CORRIGENDUM to Specific Procurement Notice (SPN) Invitation for Tenders (Reference No. 0074-PAK-01) Engineering, Procurement and Construction Works (EPC/Turnkey Basis)	
---	--	---

Name of Project: Lahore Wastewater and Drainage Management Project (LWDMP) – Sewerage System from Larechs Colony to Gulshan-e-Ravi Lahore (Through Trenchless Technology)

ADDENDUM No.1

Lahore Wastewater and Drainage Management Project (LWDMP) - Sewerage System from Larechs Colony to Gulshan E Ravi, Lahore (Through Trenchless Technology)

Annexure-A

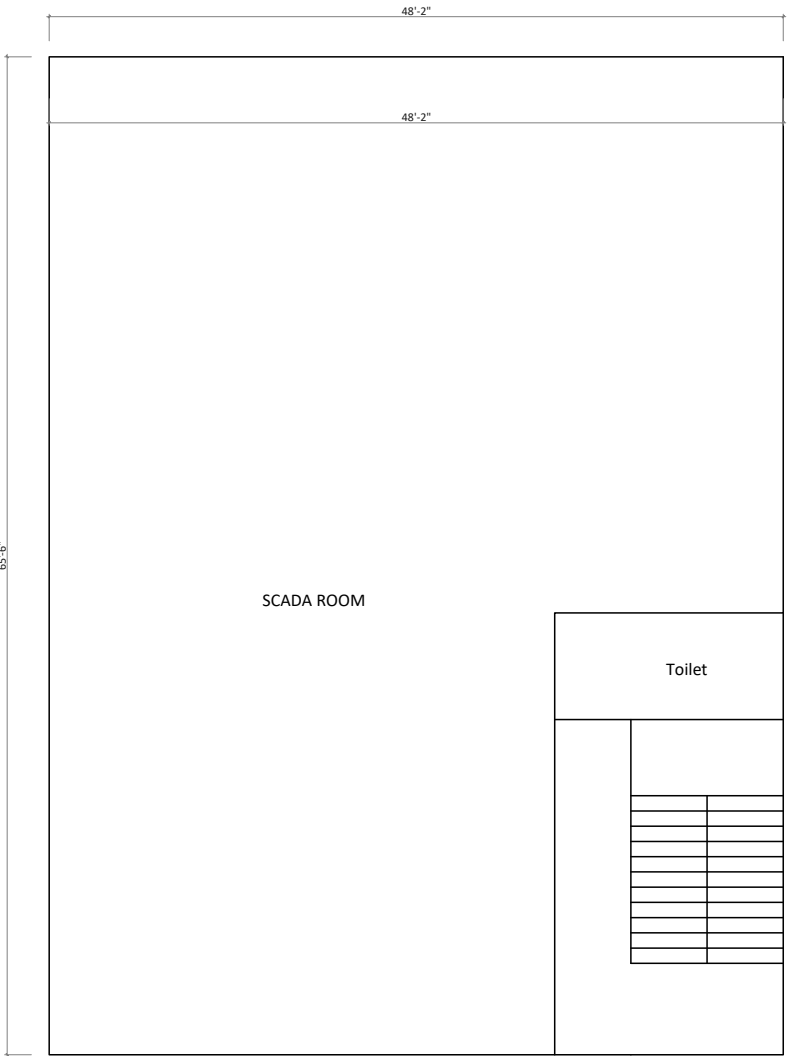
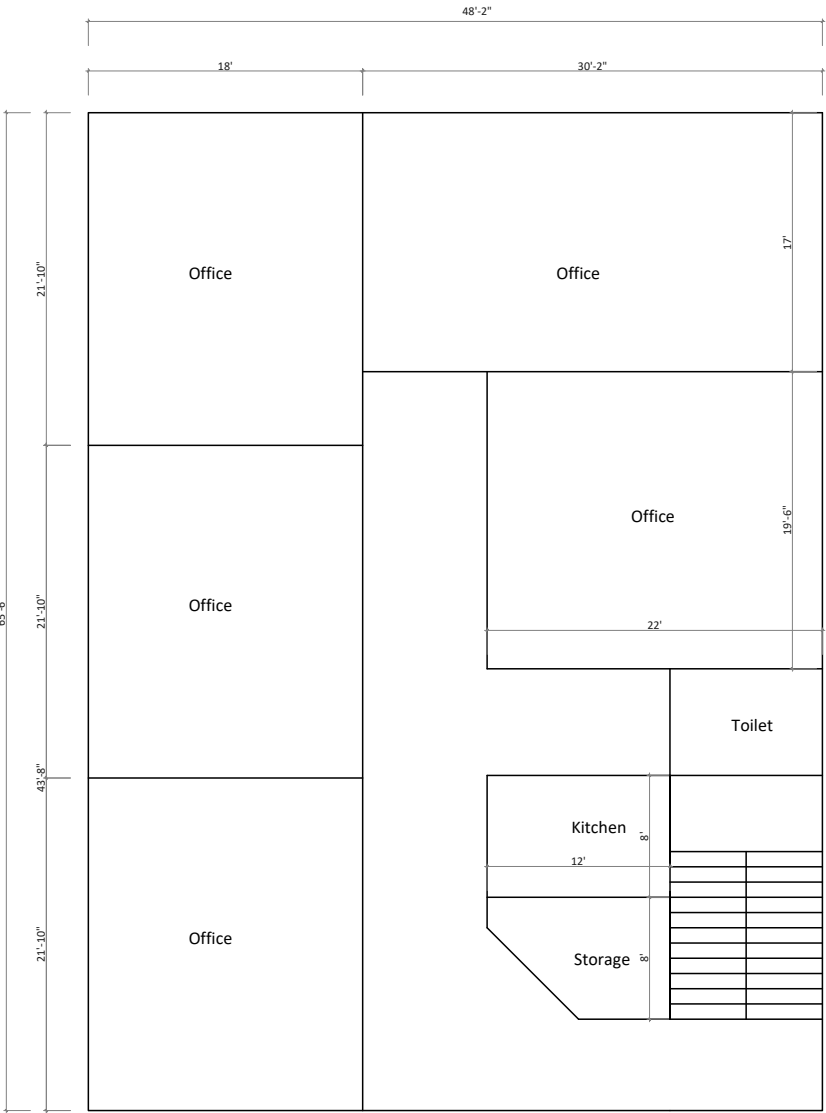
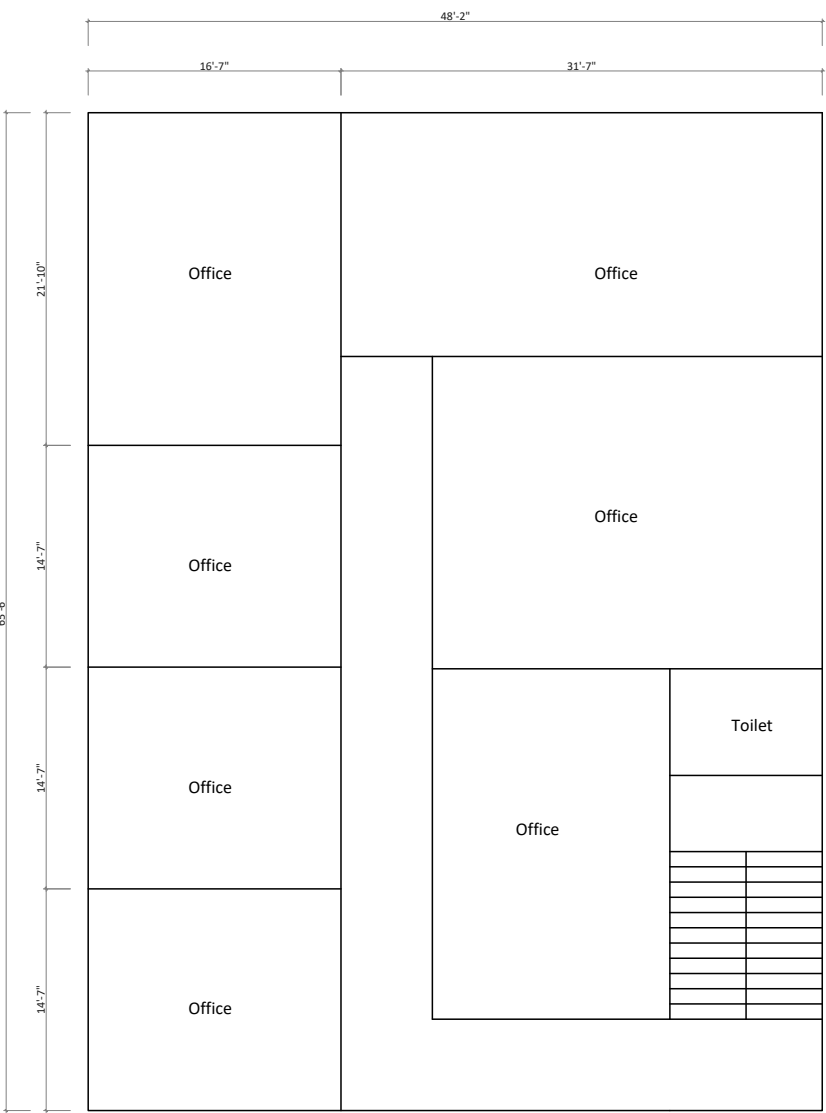
11.	Volume 2, Part II, Section 6, Employer's Requirement Clause 4.1.12, subclause xx (Construction of Office Building)	Page 6-67	<i>"However, the Contractor must first construct a fully functional three-story building other than ground floor, (500 sq. m. per floor) at the proposed location to house staff and workforce"</i>	The text in Original Clause is replaced with: <i>"However, the Contractor must first construct a fully functional three-story building other than ground floor, (296 sq. m. per floor) at the proposed location to house staff and workforce"</i> Furthermore, tentative / conceptual layout of the building is attached as Annexure-A.

12.	Volume 2, Part II, Section 6, Employer's Requirement Clause 4.1.12, subclause xx (Construction of Office Building)	Page 6-67	<i>"The Office Building in frame structure, each story having covered area of at least 500 Square meters shall be equipped with all basic amenities, washrooms, pantry, HVAC etc. with A class titles floors, fall ceilings, & wall paneling, HVAC with Info Multimedia Screen."</i>	The text in Original Clause is replaced with: <i>"The Office Building in frame structure, each story having covered area of at least 296 Square meters shall be equipped with all basic amenities, washrooms, pantry, HVAC etc. with A class titles floors, fall ceilings, & wall paneling, HVAC with Info Multimedia Screen."</i> Furthermore, tentative / conceptual layout of the building attached herewith as Annexure-A.

Sr. No.	Reference	Page no.	As Stated in Tender Documents	Revised Provisions
	Contract Data [14.15(a)(i)]			
30.	Volume 4, Part III– Conditions of Contract and Contract Forms, Section 9 – Contract Forms	Page 9-10	<i>“3.27. Construction of fully furnished three-story Office Building in frame structure, each story having covered area of at least 500 Square meter”</i>	The text in original Clause is replaced with: <i>“3.27. Construction of fully furnished ground plus three storeys office building in frame structure (total four storeys) with covered area of 296 sq-m of each floor (with elevator on outer side)”</i>

LW - TD - 177

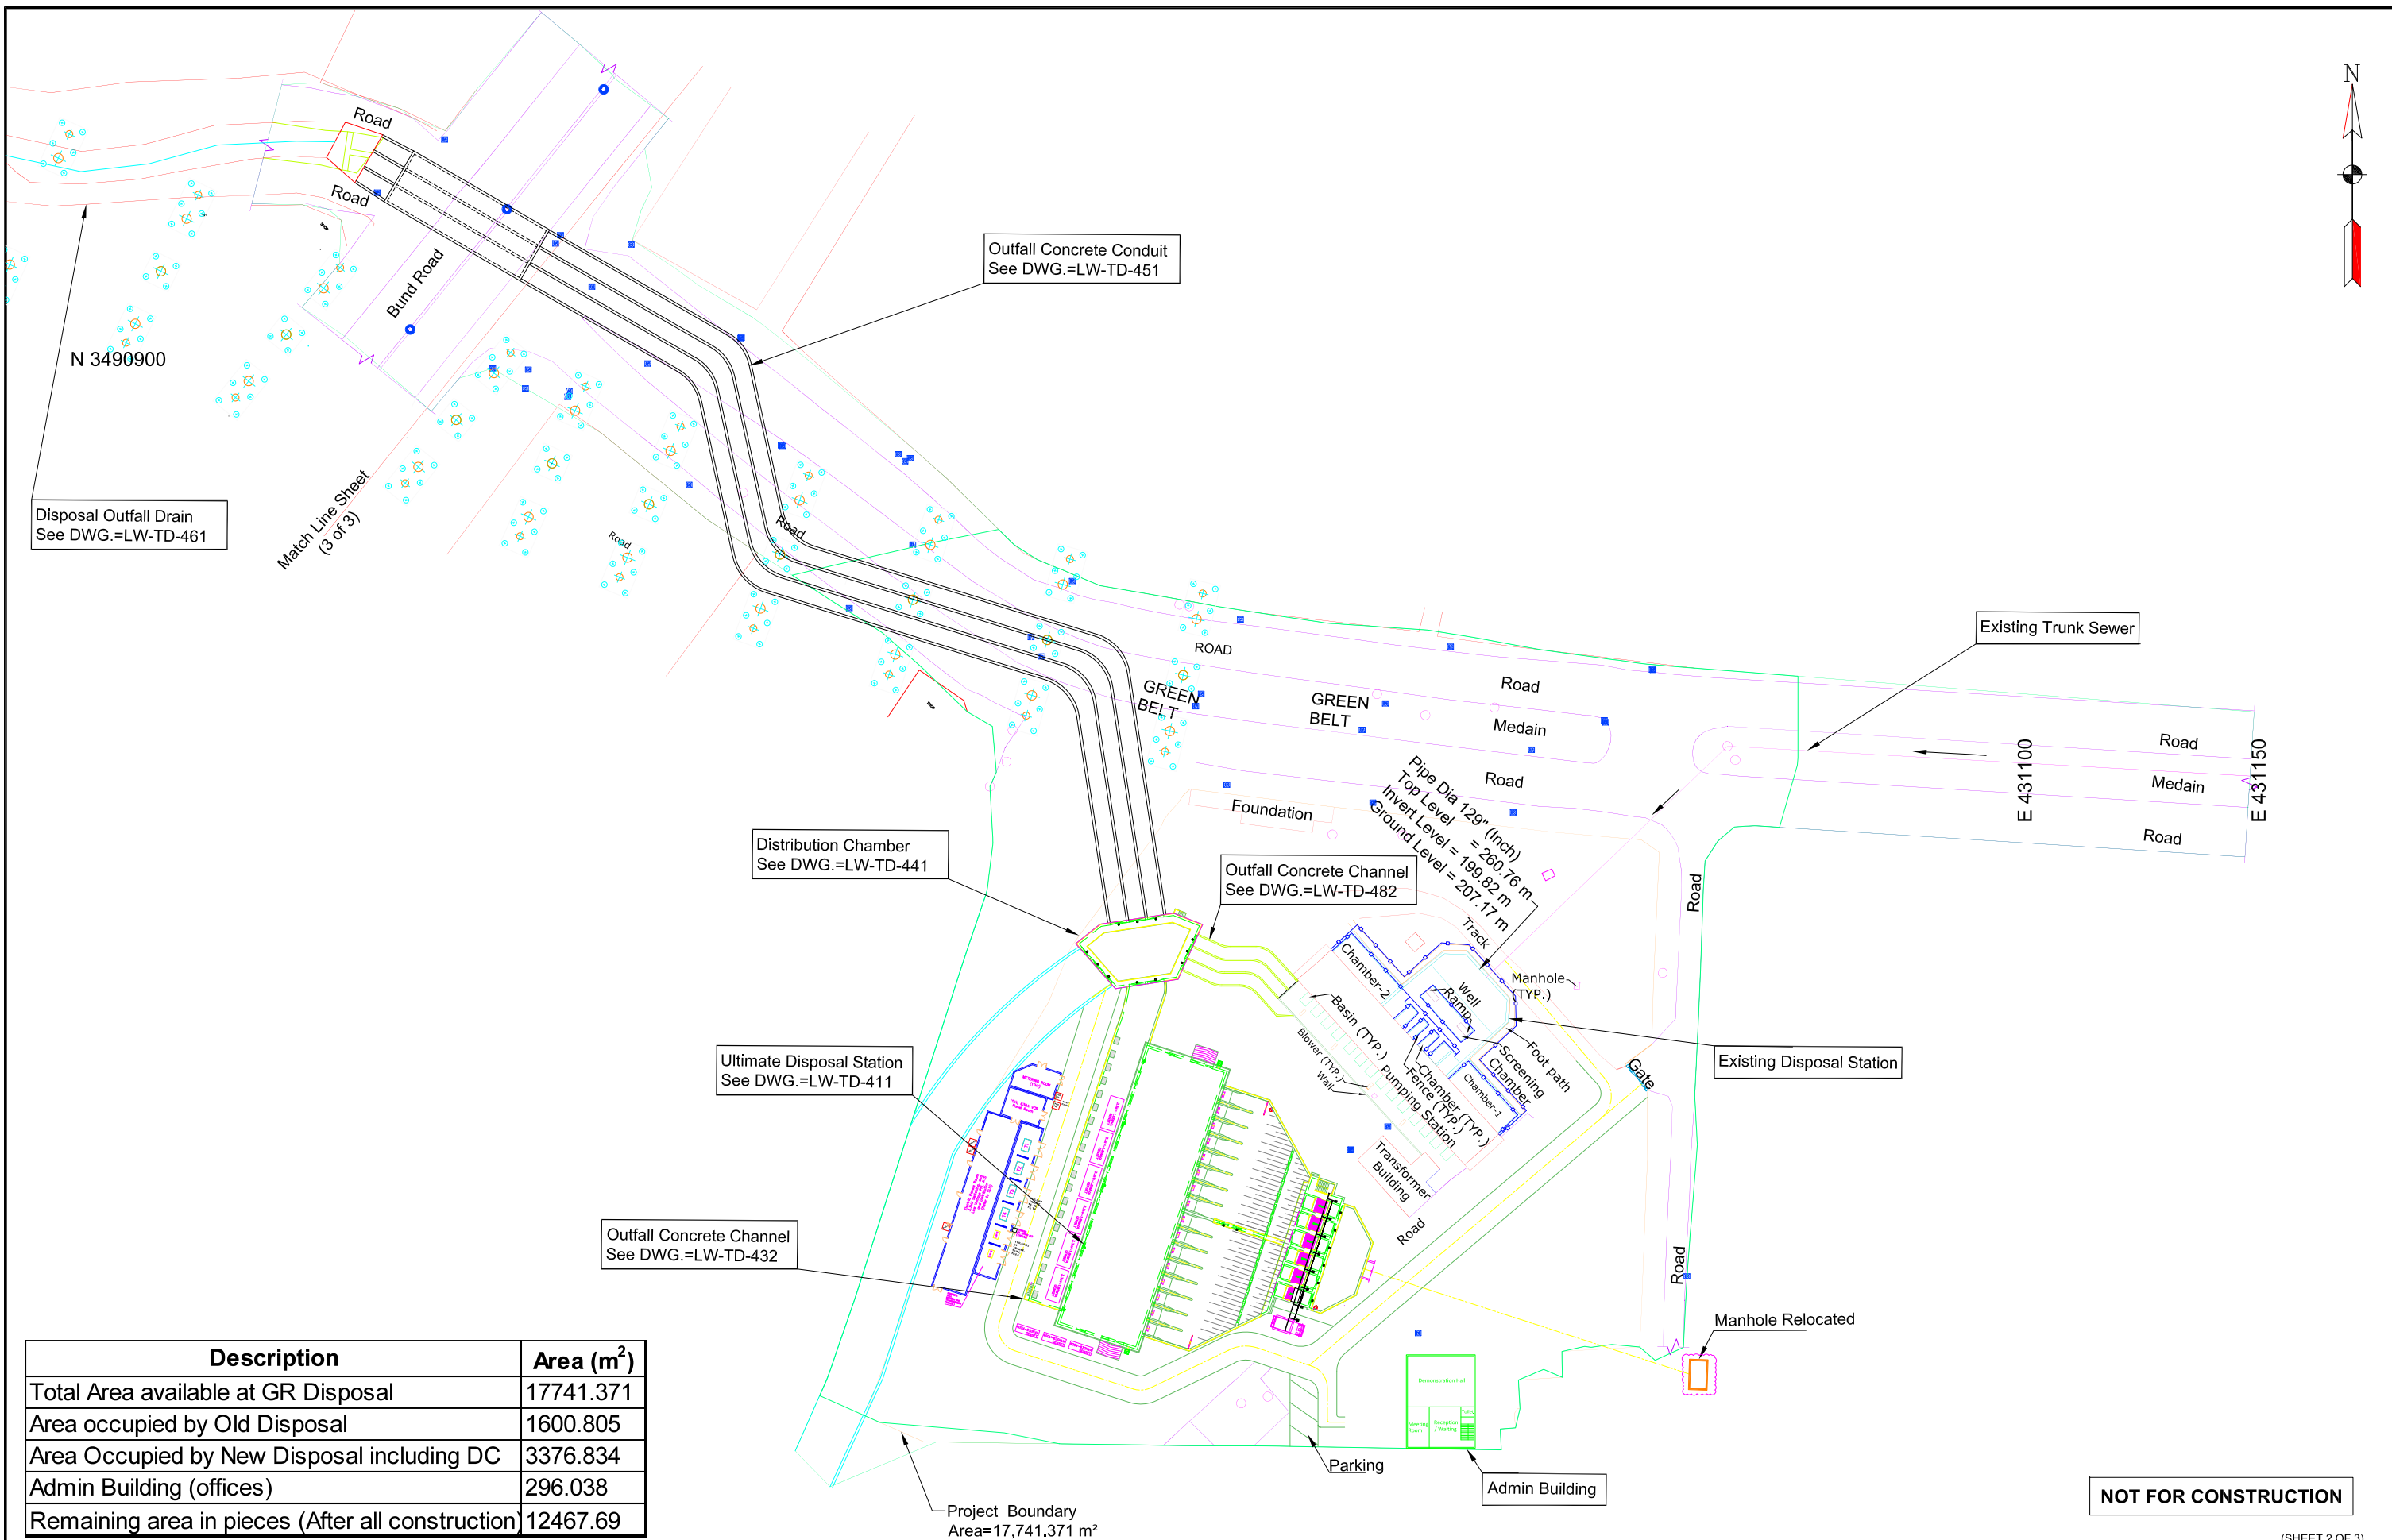
26.	Volume 3, Part II, Section 6, Employer's Requirement (Drawings)	Drawing No. LW-TD-177	-	The referenced drawing has been amended as follows: Amended Drawing No. LW-TD-177 with 29 Odour Control and Ventilation System is attached as Annexure-E in the Tender Documents. The number of Odour Control and Ventilation System anywhere in Tender Documents shall be read as Twenty-Nine (29).

25.	Volume 1, 2 & 3	Complete Tender Documents		Total number of Odour Control and Ventilation System shall be read as: 29 (Twenty-Nine). The number of Odour Control and Ventilation System anywhere in Tender Documents shall be read as 29 (Twenty-Nine).
